Bulletin # SR-5K-1705-01

## SAFETY BULLETIN

Ride Manufacturer: Dartron Industries, Inc.	Affected Production Dates: January 1998 – May 2007
Ride Name: Cliff Hanger	Affected Serial #'s: All
Model #: All

<u>Abstract of Issue:</u> Battech Enterprises, LLC has been made aware of a potentially harmful situation with the mount plate for the latch on the restraint of the passenger carrier assembly on the Cliff Hanger amusement ride.

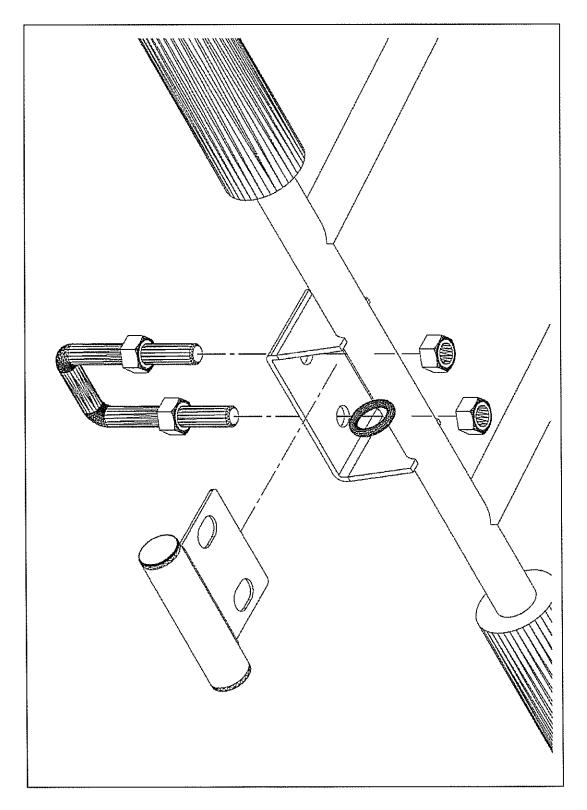
Reason for release: To ensure that all Cliff Hanger rides install a protective guard on the restraint latch mount plate to prevent potential injuries in this area. Installation procedures are included.

## Prepare Cliff Hanger for Installation of the Restraint Latch Mount Cover

- 1. The ride must be set-up to perform this operation with the restraints latched into the passenger carrier assemblies and the SPRING REEL ASSEMBLIES DISCONNECTED.
- 2. Per the attached illustration, using a ¾" wrench, remove the top two nuts that hold the threaded 'U-Bend' latch to the latch mount assembly. DO NOT ADJUST THE NUTS ON THE BOTTOM SIDE.
- 3. Without removing the 'U-Bend' from the latch mechanism of the passenger carrier assembly, install the latch mount cover over the threaded portion per the attached illustration.
- 4. Re-install the two nuts onto the threaded portion of the 'U-Bend' assembly.
- 5. Verify proper adjustment of the latch mechanism by releasing and latching a few times. Adjust as necessary.
